SUBJECT: Cumberland Farms – 835 Seaway Drive
TECHNICAL REVIEW PROJECT: # 19-43900002
DEVELOPMENT & DESIGN REVIEW (MAJOR AMENDMENT TO PD)

**RE : Cumberland Farms – 835 Seaway Drive
 Development Design Review
 TRC No. 19-43900002**

SUBJECT: **Development Review – Development & Design Review – Cumberland Farms – 835 Seaway Drive**
Technical Review Project: #19-43900002

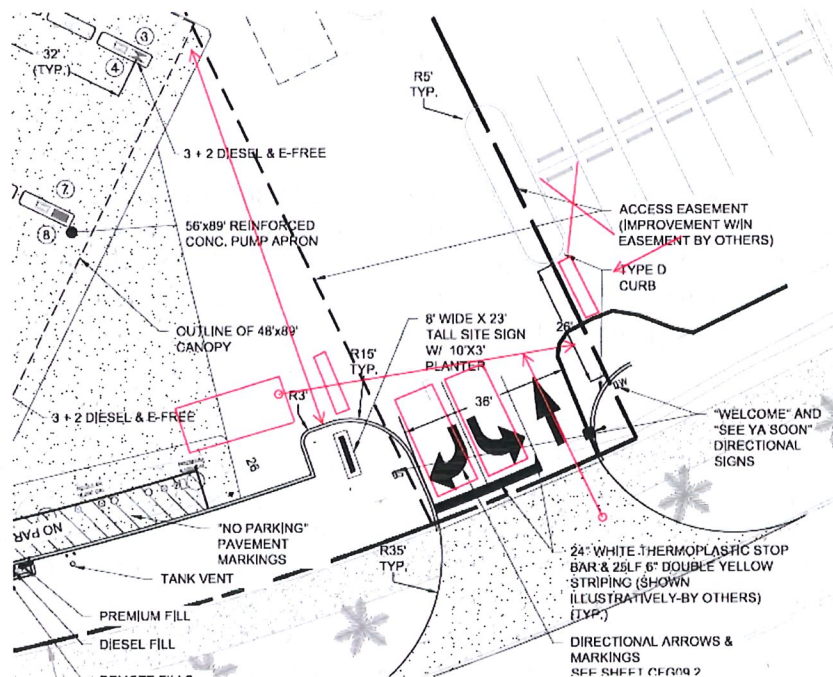
1. Please provide a Traffic Impact Report for the proposed development, inclusive of driveway analysis. Based upon the projected trip generation, access points, roadway level of service, turn lanes may be recommended. In review of the project size and type, ITE Use Code 960, Super Convenience Market/Gas Station, based upon the independent review variable of 1,000 sq. ft. GFA, the project is estimated to generate 4707 AADT, whereas much may be pass-by, however such analysis should be conducted. Based upon the proposed traffic generation, greater capacity for vehicle stacking (in an organized fashion) is encouraged to avoid back-up into Seaway Drive.

2. The City of Fort Pierce in encouraged to conduct driveway analysis of the proposed adjustment, and corresponding adjustment pending to the west, including proposed driveway location(s), internal stacking/turn lanes, proximity of the cross access driveway to the eastern parcel to the property line, future driveway location for the parcel to the west. Restoration of internal connection would provide HI residents access without placing an external trip onto the roadway.

- What are the proposed hours of operation for this establishment? The previously approved project encompassed a neighborhood commercial use, whereas the proposal appears to be a general commercial use, increase intensity for the Planned Development, with adjacent residences. The original plan adopted placed the commercial building towards the right-of-way to provide enhancement urban design, as well as greater separation of the commercial operation from adjacent residential units. Limiting hours of operation may improve compatibility, especially with the relocated building(s).
- Please consider a pedestrian connection between the proposed establishment and the development considered to the west.

- Is the applicant providing a loading space/zone for deliveries of stock or fuel? The loading area is encouraged to be located outside of the front yard, but in an area which may minimize impacts to the adjacent residences.
- The proposed parallel parking spaces (27-30) appear to conflict with the adjacent two-way driveway which reduces to a one-way exit, at the adjacent driveway. The spaces would cause movements against interior traffic flow.
- The alignment of the project's drive-aisle approaching the joint drive and adjacent project's northern most row of parking appear to cause an unsafe condition, if vehicles seek to traverse across this full access driveway to enter the western project:

- The applicant is proposing a reduction in vehicular use area landscaping based upon “preserved trees” which were planted (required) as part of the PD. The trees are required and not pre-existing to the Planned Development, therefore should not be eligible. The landscape plan should be amended to reflect the required interior vehicular use area landscaping.
- Please review clear vision areas as it pertains to proposed driveways, landscaping, etc.
